PUBLIC ARTS ADVISORY BOARD STAFF REPORT

Iron Valor CrossFit

Meeting	File No.	Application Type
June 24, 2025	2025-165-MUR-PAAB	1 Mural Permit Application
Property Owner	Applicant /Agent	
360 NE 4th Street, LLC-Jeremy Stein	Jeremy Stein	
Request

Consideration of the installation of one mural located at 360 NE 4th Street.

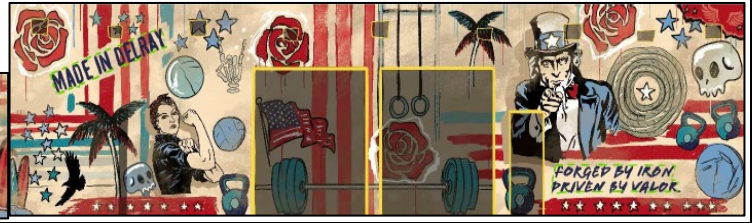
The existing building has a total of 6 façades. A “façade” is considered the exterior surface or face of a building. Therefore, each flat surface of the exterior wall of the building is considered a distinct façade.

The request is to allow the installation of one mural across the entire west façade of the existing building located at 360 NE 4th Street.

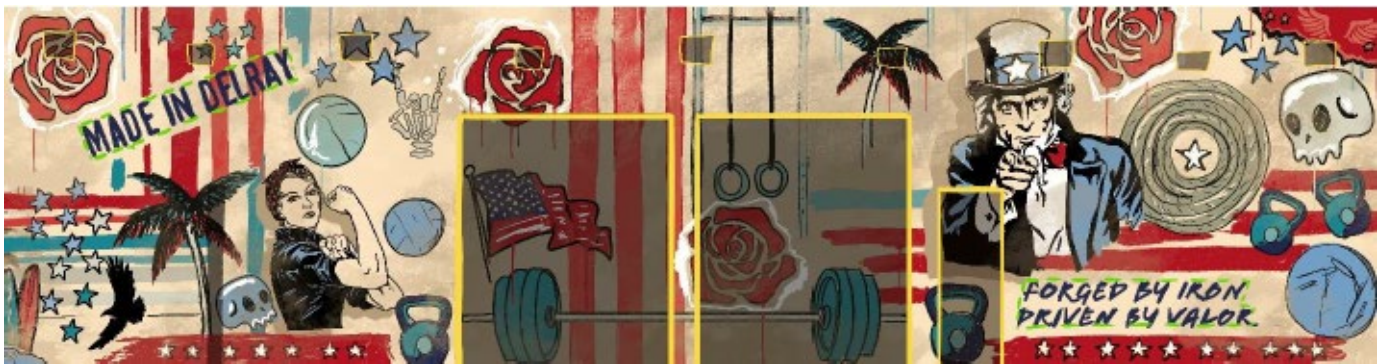
The mural on the lower façade (office) measures approximately 8 feet in height and 41.7 feet in width, covering the entire surface area. It features an Americana aesthetic, characterized by a predominant color palette of red, white, and blue. The design draws inspiration from both American history and Delray Beach's cultural legacy. Prominent elements include the historic train depot, which references the site's location adjacent to the Florida East Coast (FEC) railway and highlights the significance of this train depot owned by the historic preservation trust that is now used as a surf shop (see image below). The mural also incorporates images such as Delray Beach's Ocean waves, surfboards, and palm trees, symbols that celebrate the city's coastal identity. Additional components include the American flag and motivational words that reinforce themes of patriotism and resilience. Finally, Crossfit equipment is integrated into the design, directly connecting the mural to the business' function and purpose.

The mural on the warehouse façade measures approximately 13.75 feet in height and 64.7 feet in width, covering the entire surface area. The design reflects an Americana aesthetic, with a dominant color palette of red, white, and blue. Drawing inspiration from American history and culture, the mural features icons such as Uncle Sam and a young woman in vintage attire, symbolizing American society during the 1940s and conveying themes of patriotism, courage, and resilience. Additional elements, such as palm trees and motivational phrases, align with the business' purpose to inspire physical fitness and personal empowerment. The mural also includes references to Delray's local culture, such as the phrase "Made in Delray," along with visual elements like surfboards, palm trees, and volleyballs that evoke a distinctly Floridian atmosphere. Symbols related to fitness such as weights and lifting equipment further reinforce the imagery of the business context with the inclusion of the "forged by iron, driven by valor" further emphasized by the use of motivational words and affirmations associated with a CrossFit gym.

While the mural generally meets the LDR requirements, the Board shall consider whether the context of the text is used to create the graphic and is appropriate and promotes a constructive dialogue and uplifting mood or is the text used to brand a name or utilized as a commercial message.

The proposed mural covers 100 percent of the surface wall without obstructing any window openings and respects architectural features such as lighting, however, on the warehouse portion of the building; two overhead doors and a small exit door are proposed to be painted completely to incorporate the mural image. Although the façade includes nine headlights located at the upper area of the warehouse building, the purpose of those lights is to illuminate the driveway and not the proposed mural. The proposed murals do not include any electronic component, animated parts or any illumination that would cause glare to impair or distract the vision of motorists from the ability to safely operate their vehicle.

The theme of the mural is a continuous Americana aesthetic style, characterized by a predominant color palette of red, white, and blue drawing inspiration from both American history and Delray Beach’s cultural legacy with glimpses of a lifestyle of lifting weights, strength, grit, and prosperity. The proposed mural does not have direct signage or commercial messaging. However, both proposed facades included the text “Forge by Valor, Driven by Valor” that might be considered a commercial signage since it promotes the business named “Iron Valor”. The Board should analyze and consider if this text should be considered as a commercial sign or part of the graphic that is an integral part of the mural style.
